# 817 Deery Infill Home

Historic Zoning Committee

September 9, 2016

# Requested Porch Revision (9/9/16 Staff Report)

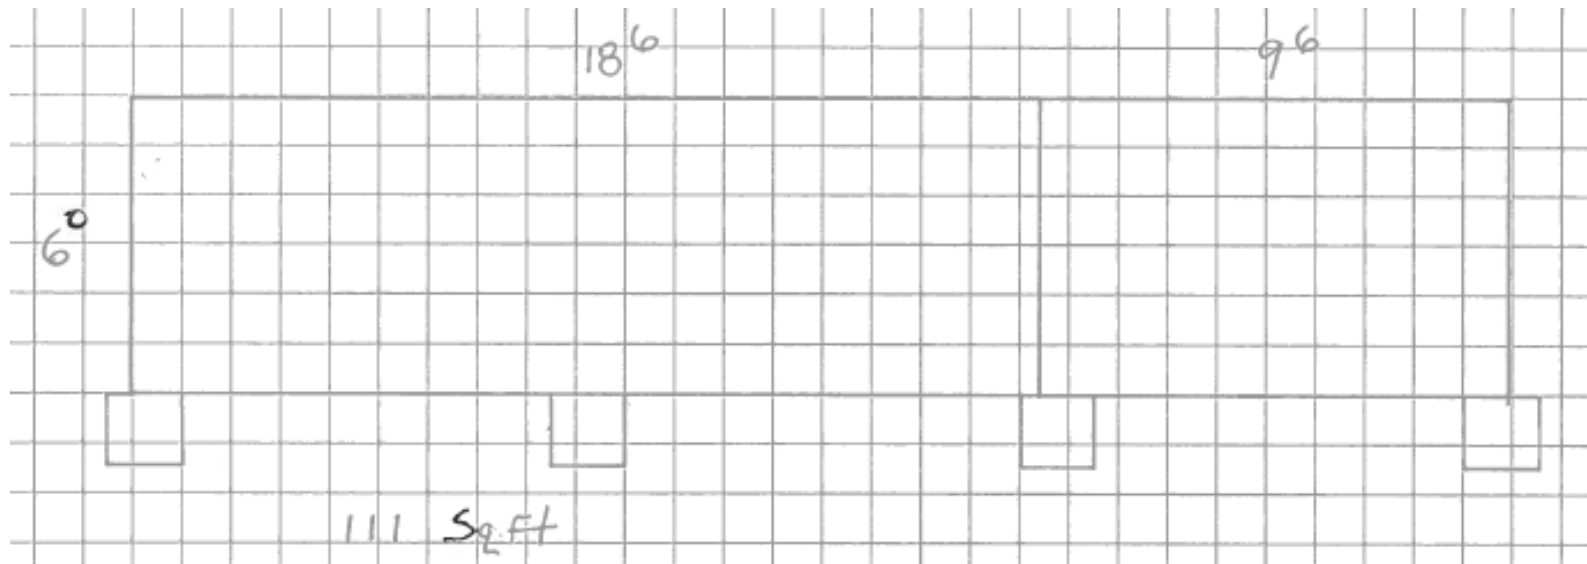
- Same as Proposed, but 7' Behind Columns
  - Alt 1 - Requires 2' growth if remainder of plan unchanged (37 ft<sup>2</sup> added to porch)
    - Revised Design
    - Revised Plot Plan
    - New Variance Required (Lot Density)
    - Another HZC Submittal
    - Reduces size of rear lot
    - Very Costly and Time Consuming

# Desired Alternative

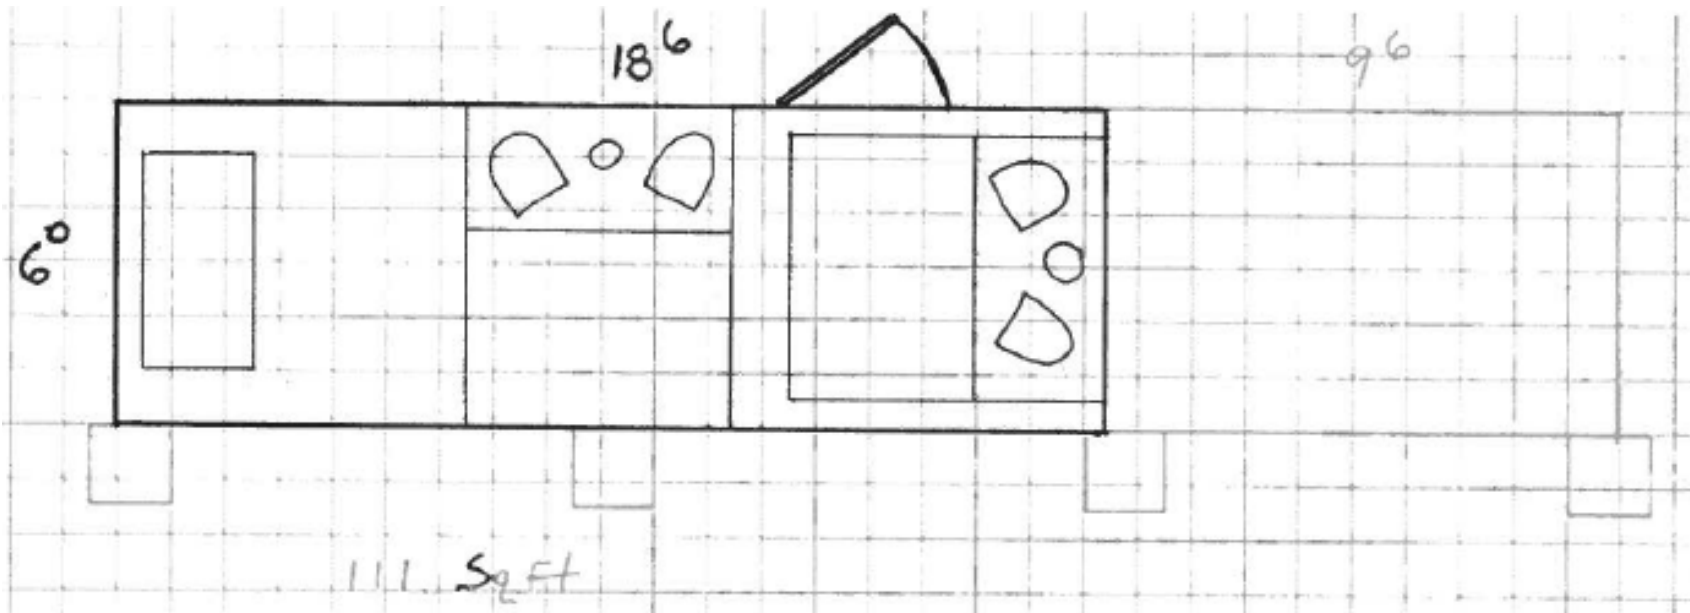
- Meets the guidelines of:
  - *Fourth & Gill Historic Neighborhood Guidelines*
    - *It is a full 6' in depth*
  - *Heart of Knoxville Infill Housing Design Guidelines (2005, 2007), p 17*
    - It is a full 6' in depth and is greater than 60 ft<sup>2</sup> (at 111 ft<sup>2</sup> )
  - Small design impact, does not require new Plot Plan, does not require New Variance, will not deduct from other living areas, and there is plenty of room for furnishings
